# Access Compliance Report

## Public Rights-of-Way

Intersection ID: 12160	Main Street: E_9TH_ST	Cross Street: N_BREVARD_ST	Location:	N
ADA ID: 3728660B4CDE	Ramp Type: Perp	Initial Pass/Fail: Fail	Overall Compliance: No	Severity Score: 10

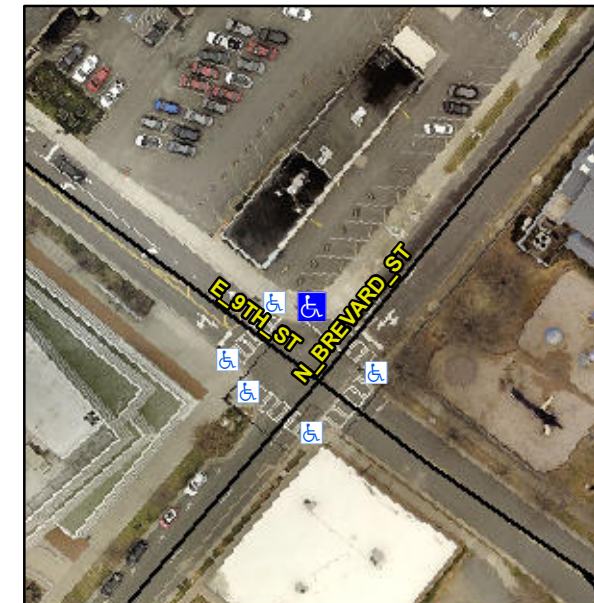
**Not Found, R304.5.1, R304.5.3**

Compliance	Description	Data	Compliance	Description	Data
N/A	Ramp Length (in)	72.0	Yes	Ramp Slope (%)	7.5
No	Ramp Width (in)	46.5	No	Ramp XSlope (%)	2.9
N/A	Flare Type LT	N/A	N/A	Flare Type RT	N/A
N/A	Flare Slope LT (%)	N/A	N/A	Flare Slope RT (%)	N/A
N/A	Flare Traversable LT?	N/A	N/A	Flare Traversable RT?	N/A
N/A	Landing Length (in)	N/A	N/A	DWS Provided?	N/A
N/A	Landing Width (in)	N/A	N/A	DWS Contrast?	N/A
N/A	Landing Slope (%)	N/A	N/A	DWS Length (in)	N/A
N/A	Landing X Slope (%)	N/A	N/A	DWS Full Width?	N/A
N/A	Landing Curb? (Y/N)	N/A	N/A	DWS Offset (in)	N/A
N/A	Shared Landing?	N/A			
N/A	Gutter Ponding?	N/A	N/A	Gutter Slope (%)	N/A
N/A	Gutter Lip Ht (in)	N/A	N/A	Gutter X Slope (%)	N/A
N/A	Painted X Walk1?	Yes	N/A	Painted X Walk2?	N/A
	X Walk 1 Direction	To SE		X Walk 2 Direction	N/A
N/A	X Walk 1 Width (in)	104.0	N/A	X Walk 2 Width (in)	N/A
	X Walk 1 Slope (%)	1.7		X Walk 2 Slope (%)	N/A
	X Walk 1 X Slope (%)	1.1		X Walk 2 X Slope (%)	N/A

**Remove & Replace Entire Ramp.**
